QUALITY ASSURANCE -- NON-CONFORMANCE REPORT

Report No: NCR-000796

Reference Description: Heat Straightening without Prior Approval from the Engineer

Job Name: SAS Superstructure

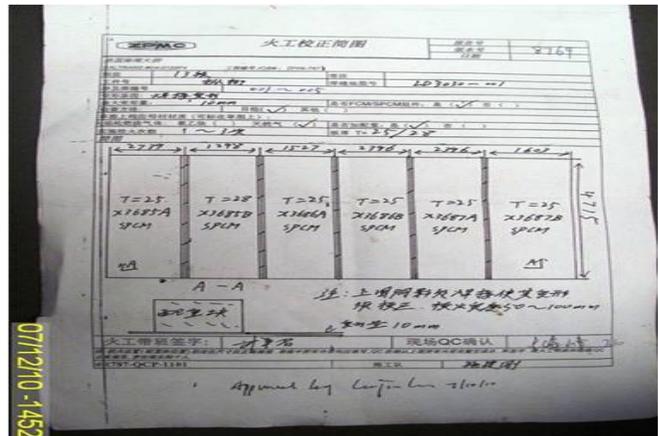
During Quality Assurance (QA) in-process observations of the fabrication of Longitudinal diaphragm LD3030-001, QA discovered the following issue:

- ZPMC personnel performing heat straightening on distorted member without prior Engineer's approval.
- The Longitudinal Diaphragm is identified as LD3030-001.
- The plates are identified as X3685A (SPCM), X3685B (SPCM), X3686A (SPCM), X3686B (SPCM), X3687A (SPCM), and X3687B (SPCM).
- The deviation from flat as measured by QA was 14mm in 1000mm.
- The Material thickness is 25 mm and 28 mm.
- This Longitudinal Diaphragm is located in Sub assembly Bay#3.

AWS D1.5/2002 Section 3.7.3: "Members distorted by welding shall be heat straightened by mechanical means or by carefully supervised application of a limited amount of localized heat as approved by the Engineer".

Caltrans Special Provisions Section 8-3: "For material more than 16 mm, the Contractor shall not heat straighten members more than 3 in 1000 without prior approval of the Engineer".

Reference Resolution: The length of the plate is 12 meters long, so the plate would have to be out of flatness greater than 36mm before Engineer approval is needed.

Measuring determining flatness using 1 meter is not sufficient to determine the if the flatness is out of tolerance, see Item 11.2.2.b from Letter 05.03.01-000419. The tolerance referenced in Section 8-3, Special Provisions (3 over 1000mm) should be used as a ratio when the length of the plate is longer than 1 meter. In this case the length of the plate is 12 meters long, so the plate would have to be out of flatness greater than 36mm before Engineer approval is needed. Based on this clarification and that ZPMC had a valid HSR1 in hand at the time, ZPMC requests this NCR be closed.

The proposed resolution is acceptable. This NCR is considered closed.

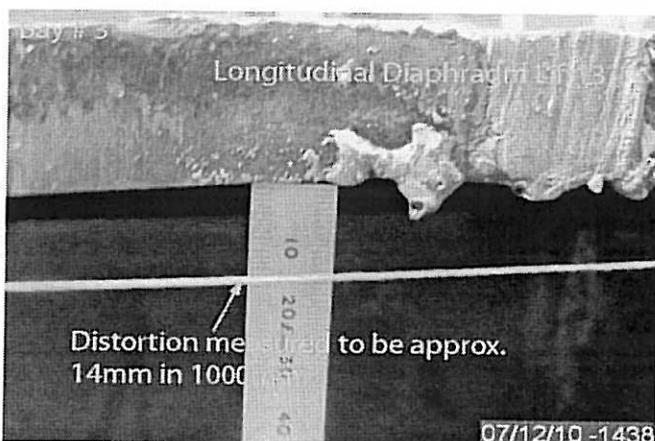
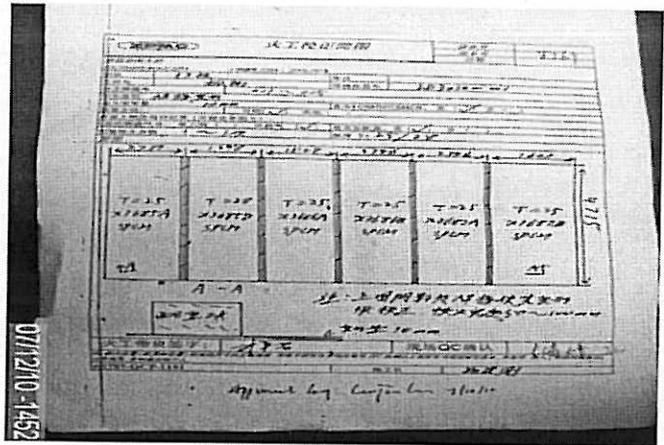
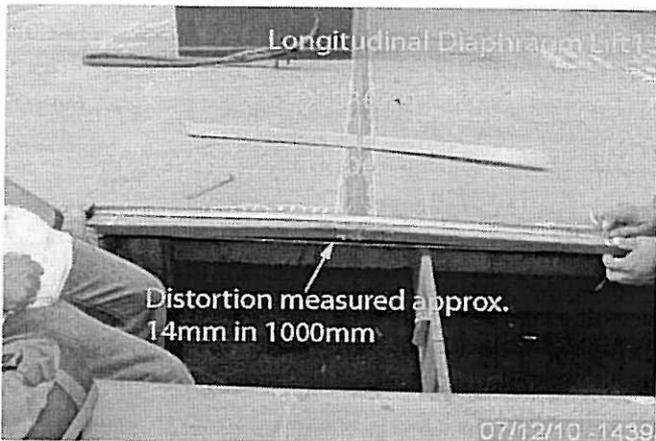
During Quality Assurance (QA) in-process observations of the fabrication of Longitudinal diaphragm LD3030-001, QA discovered the following issue:

- ZPMC personnel performing heat straightening on distorted member without prior Engineer's approval.
- The Longitudinal Diaphragm is identified as LD3030-001.
- The plates are identified as X3685A (SPCM), X3685B (SPCM), X3686A (SPCM), X3686B (SPCM), X3687A (SPCM), and X3687B (SPCM).
- The deviation from flat as measured by QA was 14mm in 1000mm.
- The Material thickness is 25 mm and 28 mm.
- This Longitudinal Diaphragm is located in Sub assembly Bay#3.

AWS D1.5/2002 Section 3.7.3: "Members distorted by welding shall be heat straightened by mechanical means or by carefully supervised application of a limited amount of localized heat as approved by the Engineer".

Caltrans Special Provisions Section 8-3: "For material more than 16 mm, the Contractor shall not heat straighten members more than 3 in 1000 without prior approval of the Engineer".

After review, it has been determined that this NCR was issued in error and will be rescinded.
